PRODUCT CHANGE NOTIFICATION (PCN)

AMJG0808-0300-BKB-26 MODULAR CABLE

| CHANGE NOTIFICATION: | PCN 20220425_AMJG0808-0300-BKB-26 |
| DESCRIPTION OF CHANGES: | CHANGE OF DATA SHEET CHANGE OF DATA SHEET New Draw.-No. ASS_7947_CArev02 |

| ASSMANN WSW P/N | Drawing Number | | ASSMANN WSW P/N | Drawing Number |
|----------------------|------------------|---|----------------------|------------------|
| AMJG0808-0300-BKB-26 | ASS_7947_CArev01 | ↔ | AMJG0808-0300-BKB-26 | ASS_7947_CArev02 |

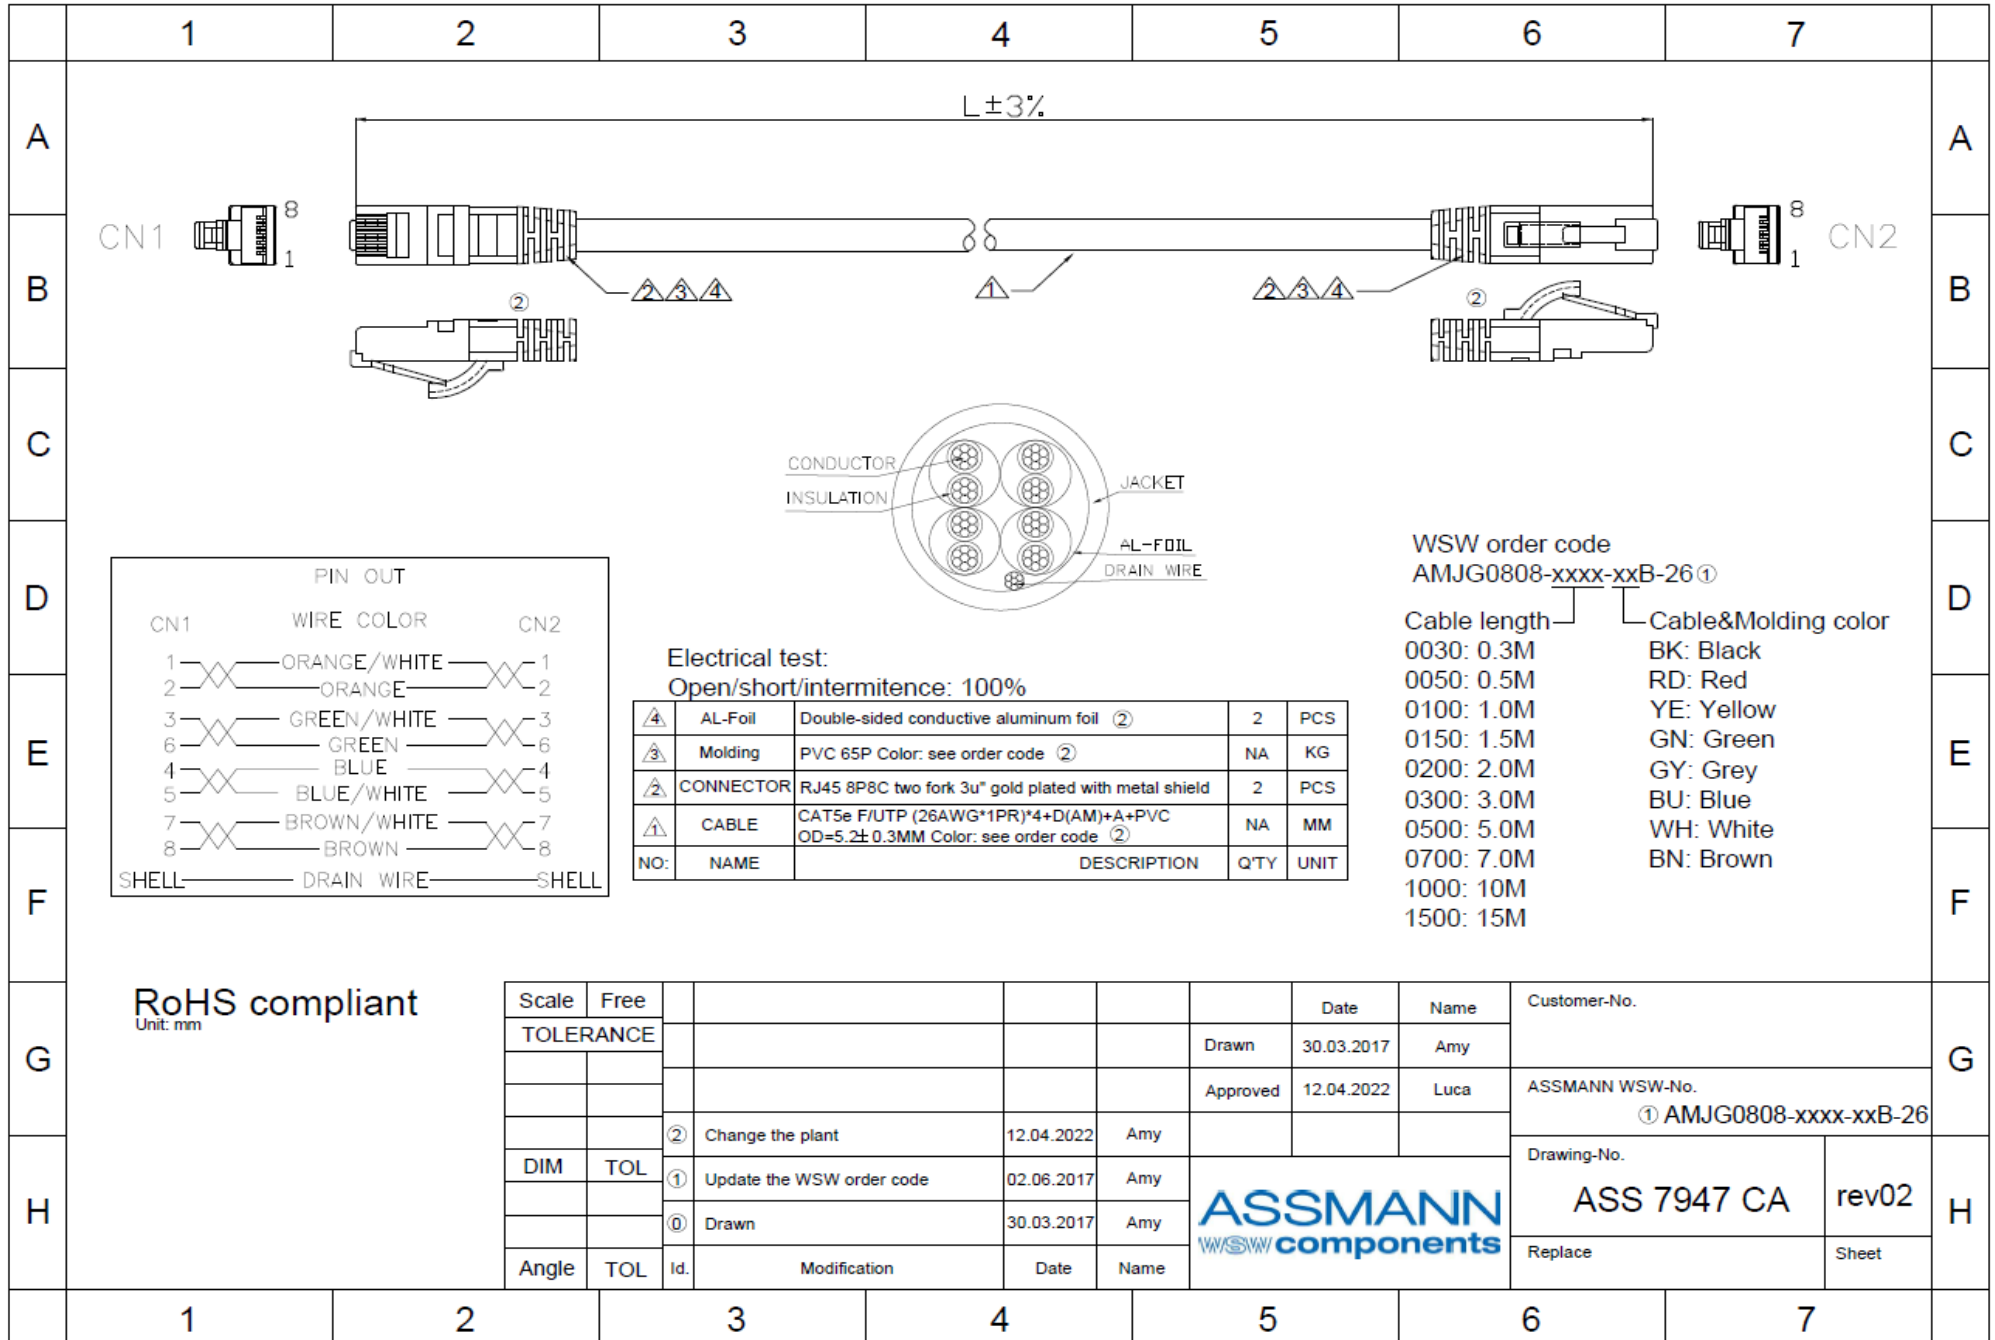
| AMJG0808-0300-BKB-26 | OLD VERSION | AMJG0808-0300-BKB-26 | NEW VERSION | | | | | | | | | | | | | | | | | | | | | | | | | | | | | | | | | | | | | | | | | | | | | |
| <p>BOM</p> <table border="1"> <thead> <tr> <th>NO:</th> <th>NAME</th> <th>DESCRIPTION</th> <th>Q'TY</th> <th>UNIT</th> </tr> </thead> <tbody> <tr> <td>③</td> <td>Molding</td> <td>PVC 45P Color: see order code</td> <td>NA</td> <td>KG</td> </tr> <tr> <td>②</td> <td>CONNECTOR</td> <td>RJ45 8P8C two fork 3u" gold plated with metal shield</td> <td>2</td> <td>PCS</td> </tr> <tr> <td>①</td> <td>CABLE</td> <td>CAT5e FTP (26AWG*1PR)*4+D+A+PVC OD=5,2±0,3MM Color: see order code</td> <td>NA</td> <td>MM</td> </tr> </tbody> </table> | | NO: | NAME | DESCRIPTION | Q'TY | UNIT | ③ | Molding | PVC 45P Color: see order code | NA | KG | ② | CONNECTOR | RJ45 8P8C two fork 3u" gold plated with metal shield | 2 | PCS | ① | CABLE | CAT5e FTP (26AWG*1PR)*4+D+A+PVC OD=5,2±0,3MM Color: see order code | NA | MM | <p>BOM</p> <table border="1"> <thead> <tr> <th>NO:</th> <th>NAME</th> <th>DESCRIPTION</th> <th>Q'TY</th> <th>UNIT</th> </tr> </thead> <tbody> <tr> <td>⚠</td> <td>AL-Foil</td> <td>Double-sided conductive aluminum foil ②</td> <td>2</td> <td>PCS</td> </tr> <tr> <td>⚠</td> <td>Molding</td> <td>PVC 65P Color: see order code ②</td> <td>NA</td> <td>KG</td> </tr> <tr> <td>⚠</td> <td>CONNECTOR</td> <td>RJ45 8P8C two fork 3u" gold plated with metal shield</td> <td>2</td> <td>PCS</td> </tr> <tr> <td>⚠</td> <td>CABLE</td> <td>CAT5e F/UTP (26AWG*1PR)*4+D(AM)+A+PVC OD=5,2±0,3MM Color: see order code ②</td> <td>NA</td> <td>MM</td> </tr> </tbody> </table> | | NO: | NAME | DESCRIPTION | Q'TY | UNIT | ⚠ | AL-Foil | Double-sided conductive aluminum foil ② | 2 | PCS | ⚠ | Molding | PVC 65P Color: see order code ② | NA | KG | ⚠ | CONNECTOR | RJ45 8P8C two fork 3u" gold plated with metal shield | 2 | PCS | ⚠ | CABLE | CAT5e F/UTP (26AWG*1PR)*4+D(AM)+A+PVC OD=5,2±0,3MM Color: see order code ② | NA | MM |
| ⚠ | AL-Foil | Double-sided conductive aluminum foil ② | 2 | PCS | | | | | | | | | | | | | | | | | | | | | | | | | | | | | | | | | | | | | | | | | | | | |
| ⚠ | Molding | PVC 65P Color: see order code ② | NA | KG | | | | | | | | | | | | | | | | | | | | | | | | | | | | | | | | | | | | | | | | | | | | |
| ⚠ | CABLE | CAT5e F/UTP (26AWG*1PR)*4+D(AM)+A+PVC OD=5,2±0,3MM Color: see order code ② | NA | MM | | | | | | | | | | | | | | | | | | | | | | | | | | | | | | | | | | | | | | | | | | | | |
